(MQY) SMYRNA, SMYRNA, TENNESSEE, ILS OR LOC RWY 32, AMDT 7

6-16-22 PRB RESULT: RETURN FOR REWORK:

Smyrna, Smyrna, TN (KMQY) - ILS OR LOC RWY 32 AMDT 7

ILS or LOC RWY 32
SMYRNA (MQY)

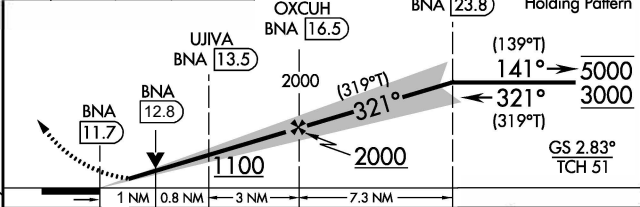
FLIGHT INSPECTOR REMARKS: The Initial inspection for the procedure started on 2023-08-03, N84. Unable to complete the MAPCH portion due to BNA VORTAC O/S. The missed approach instruction to fly heading 080 does not intercept the BNA R-104. Suggest a heading between 045-060.							
IN-FLIGHT OBSTACLE REPORT							
OBSTRUCTION ID #:	COORDINATES OR LOCATION:		GNSS ALTITUDE (MSL):		BAROMETRIC ALTITUDE (MSL):		HEIGHT ABOVE GROUND LEVEL:

MISSED APPROACH: Climb to 1500 then climbing right turn to 3000 on heading 060° and on BNA VORTAC R-104 to WORDU/BNA 18.6 DME and hold.
